**PRELIMINARY  
STORM WATER MANAGEMENT PLAN  
FOR  
QUARRY CREEK  
(CT 11-04)**

**(VESTING TENTATIVE MAP)**

**Rick Engineering Company**  
**Response to City of Carlsbad plan check titled “3<sup>rd</sup> Review for Quarry Creek Master Plan**  
**– GPA 11-09/ZC 11-04/MP 10-01/CT 11-04/SUP 11-04/HMP 11-07/HDP 11-04” dated**  
**January 31, 2012**

**Plan Check Comments #2**  
**March 13, 2012**

# Hydrologic Unit Basin Map

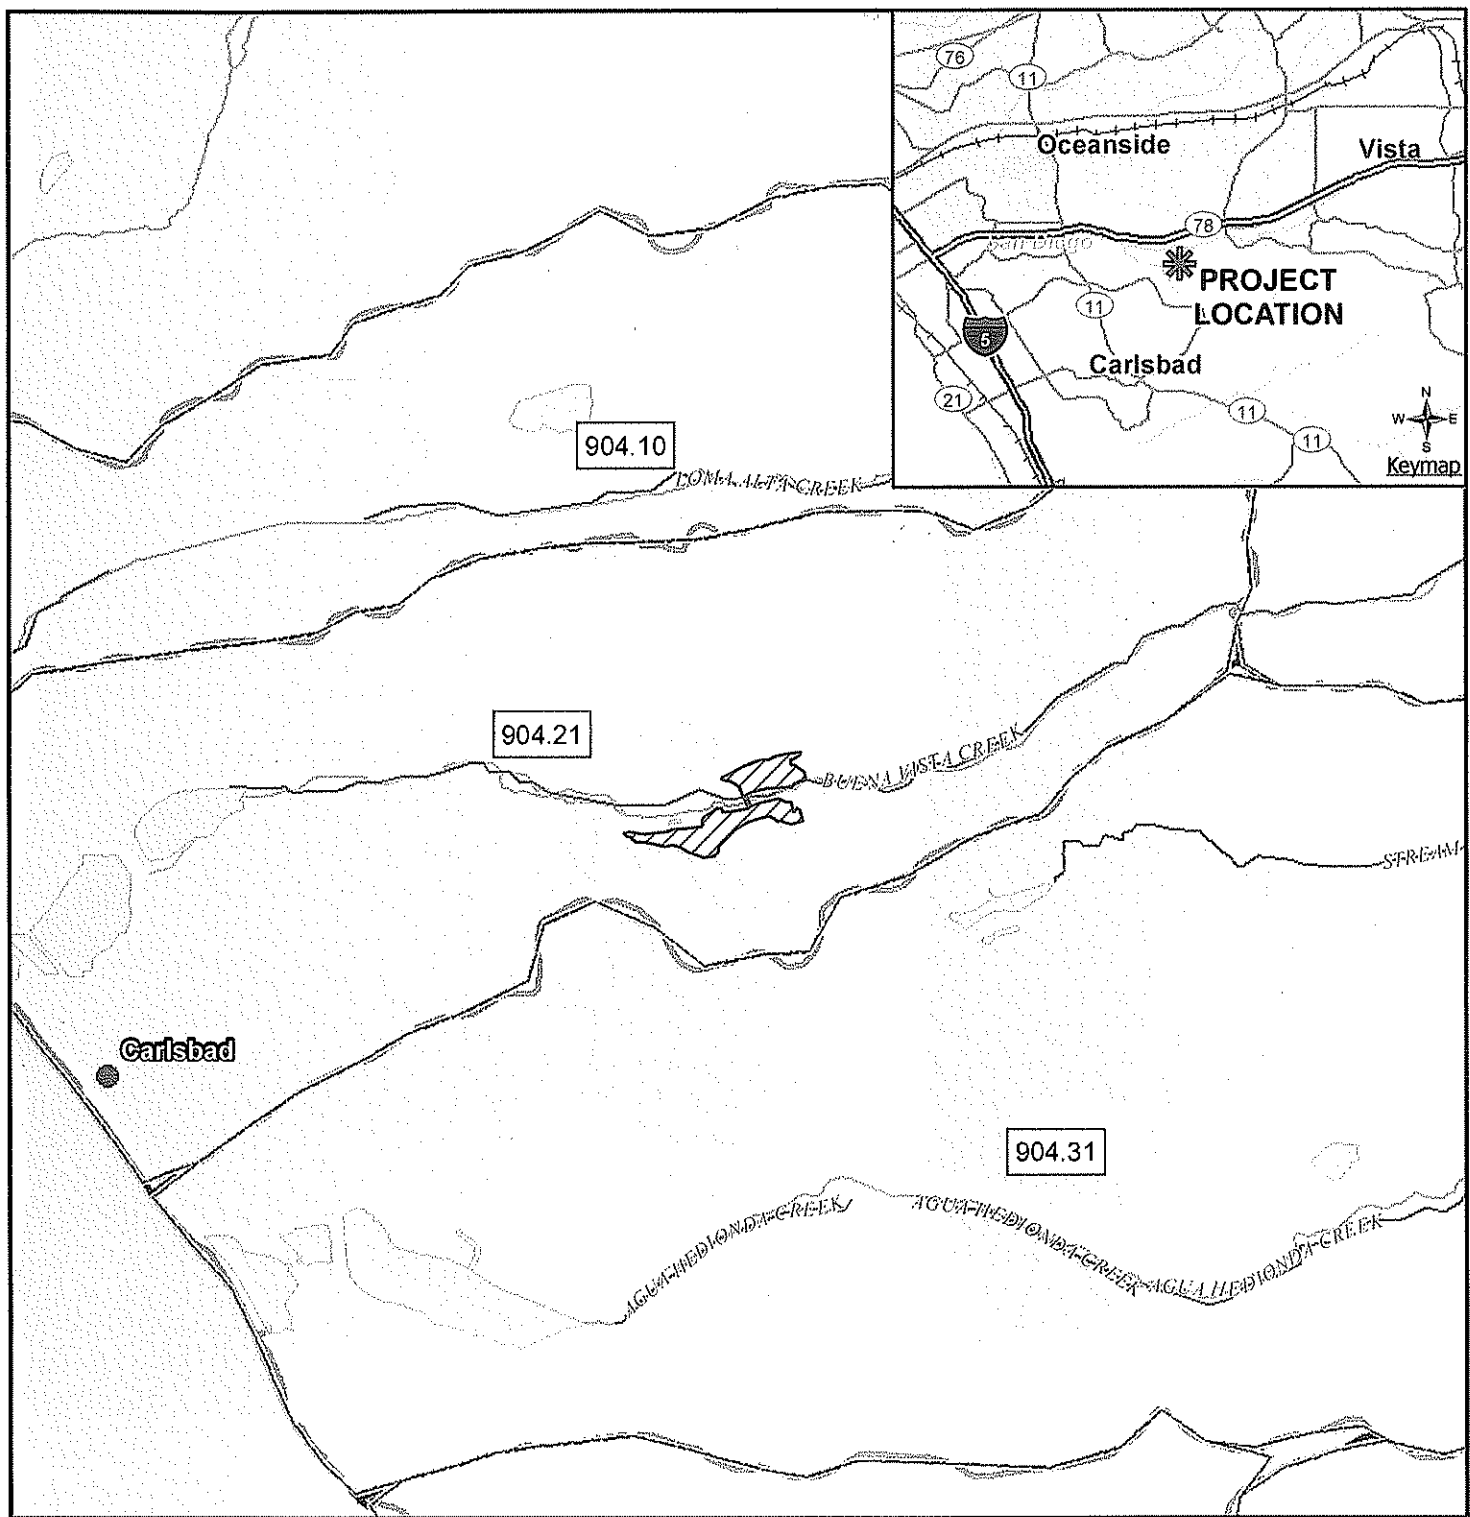
Comment 37: *On page 10, under identification of receiving waters, it is indicated that an exhibit titled “Hydrologic Unit for Quarry Creek” has been provided in Appendix B. However, Appendix B contains only the HMP applicability determination matrix.*

Response: The SWMP has been revised to include the exhibit titled “Hydrologic Unit for Quarry Creek” in Appendix B.

**DMA/IMP/BMP Exhibit**

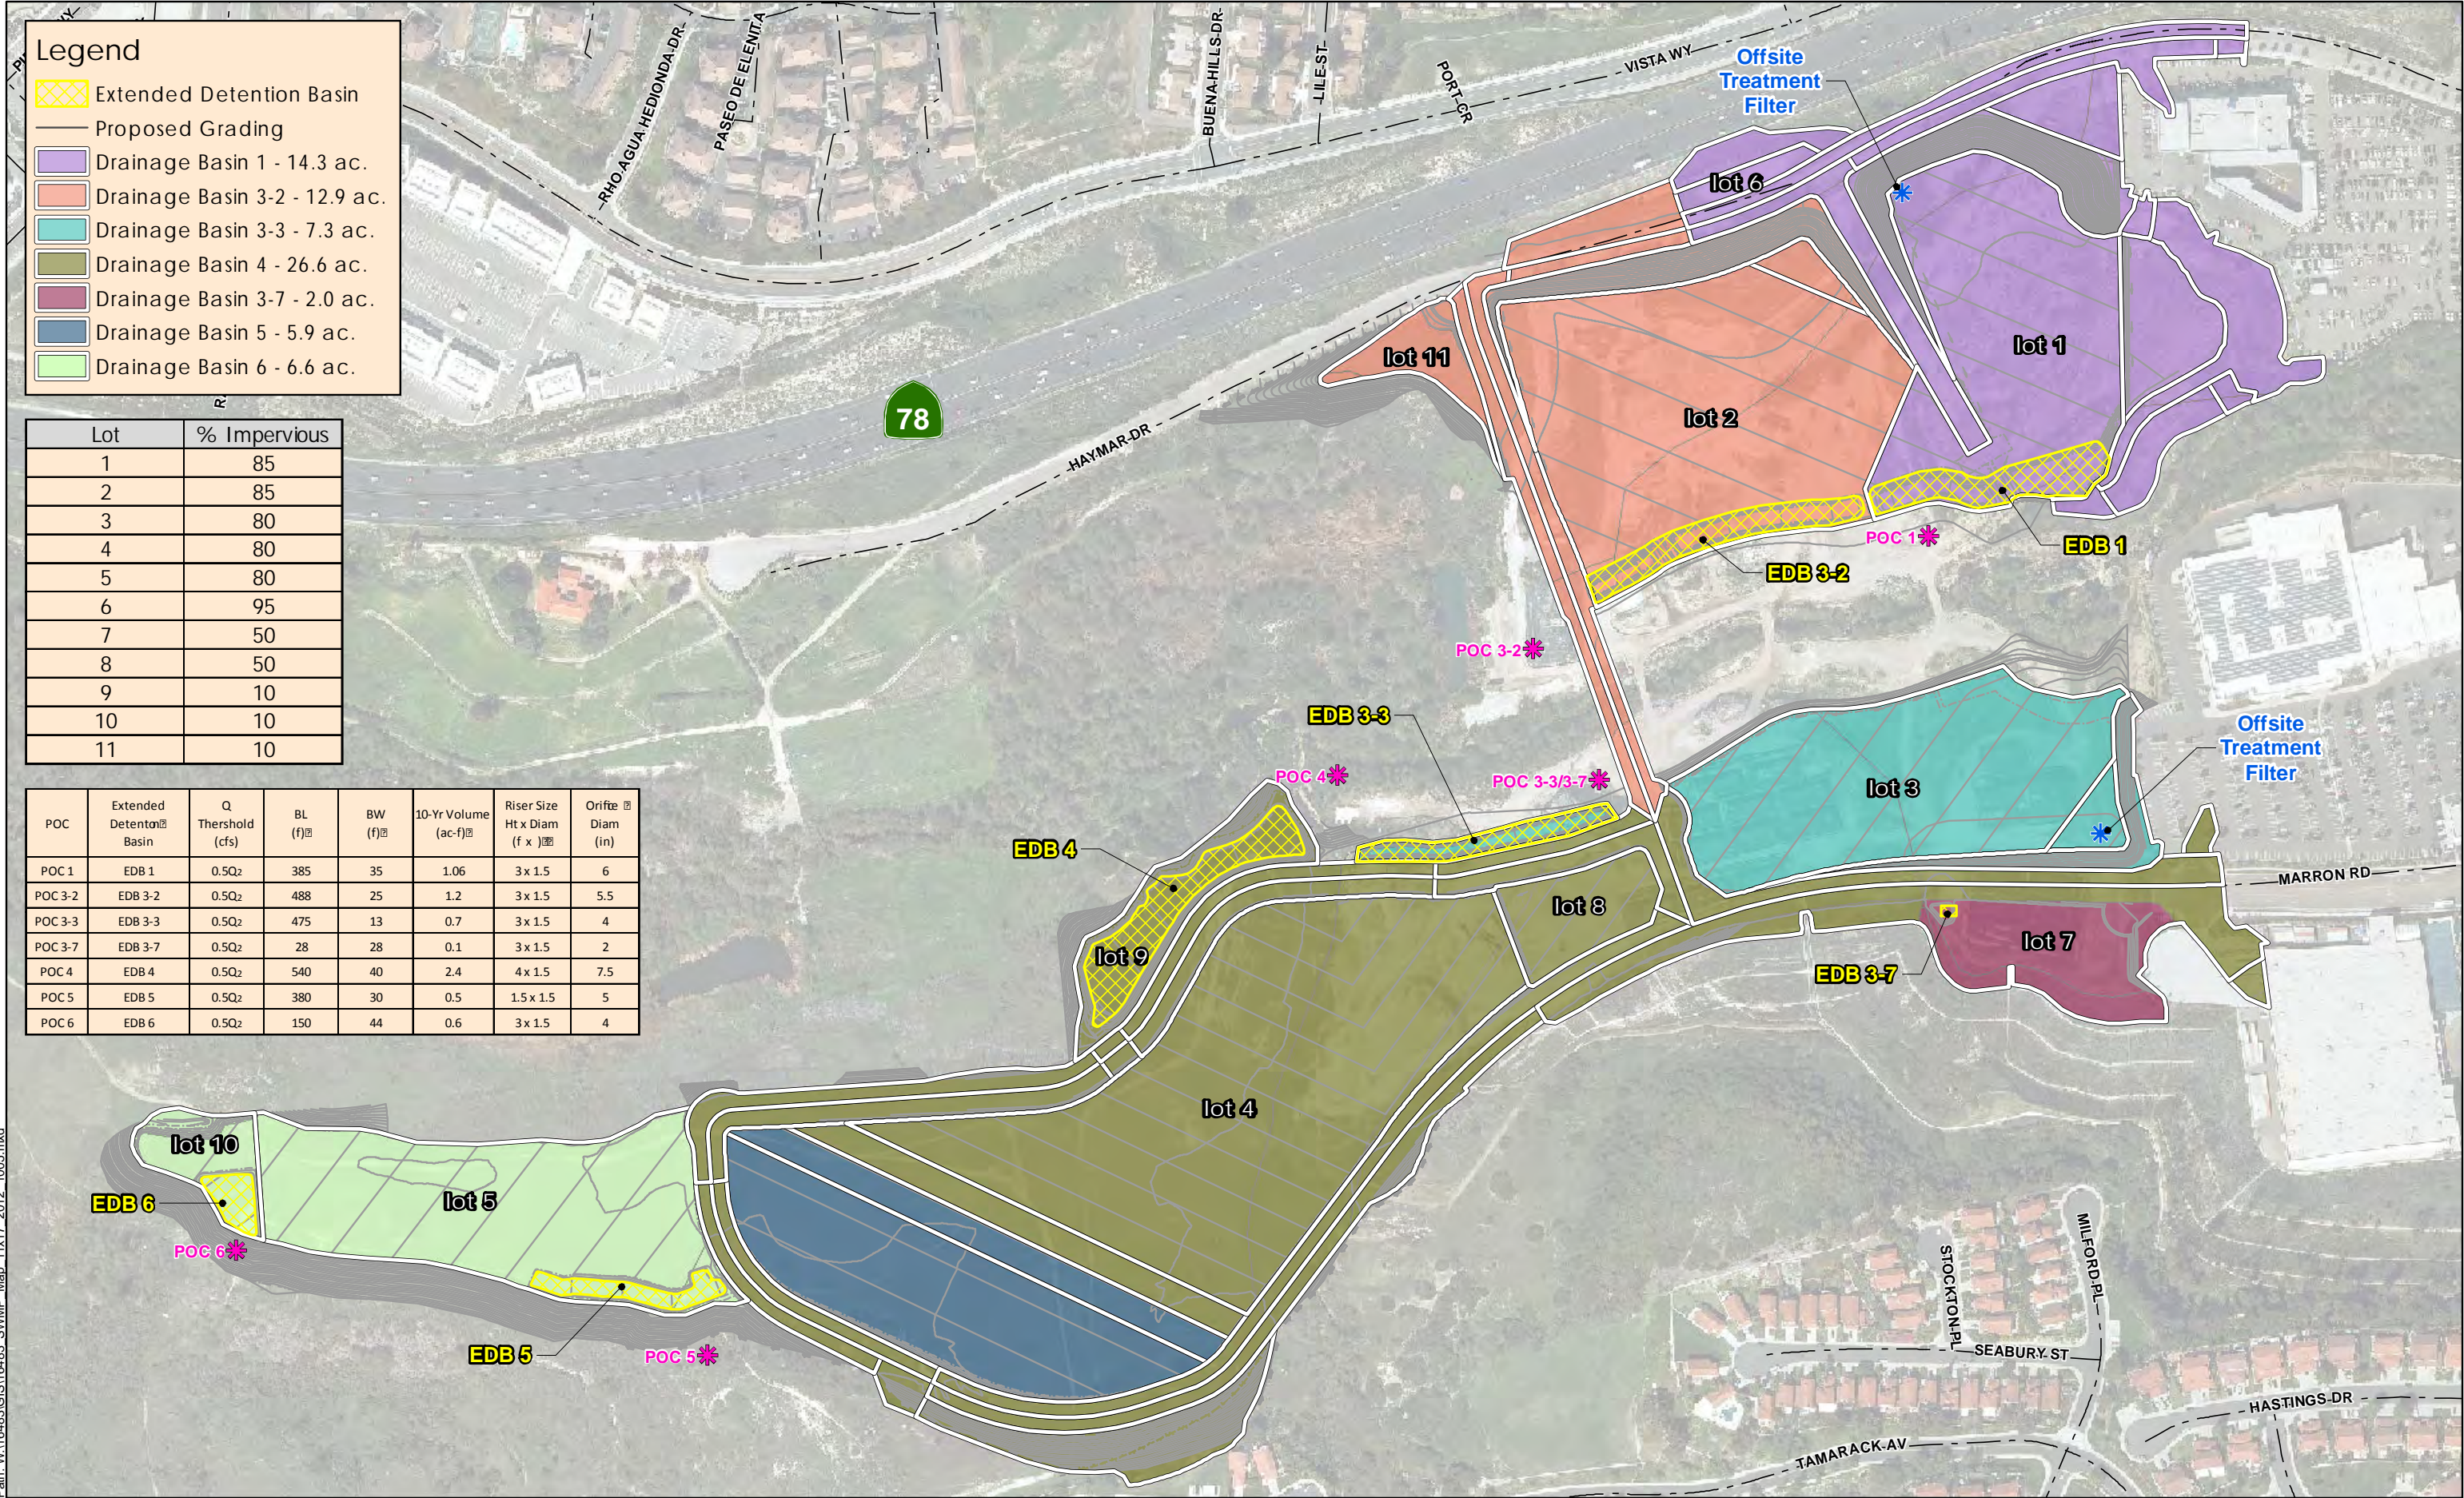
Comment 25: *Please provide a drainage basin map showing the locations of drainage basins 1 to 4 and its sub-basins mentioned in the SWMP report. The third paragraph on page 4 refers to the exhibit in Appendix E for locations of drainage basins. However, the Storm Water Management Exhibit found in Appendix E includes only the DMAs, IMPs/BMPs but not the drainage basins.*

Comment 26: *The SWMP exhibit in Appendix E must include a summary table that shows the required sizes of each of the proposed IMPs/BMPs, including length, width, orifice diameter, and details of the outlet structures, including mechanism to avoid orifice clogging. A full size SWMP exhibit must be added to the tentative map/site plan.*

Response: The Storm Water Management exhibit has been revised to more clearly show the major drainage basins and sub-basins. The drainage basins are color coded and labeled according to the POC to which it discharges.

Response: The SWMP exhibit has been revised to include a summary table showing the required information as stated above. A full size SWMP exhibit has been included in the tentative map/site plan.
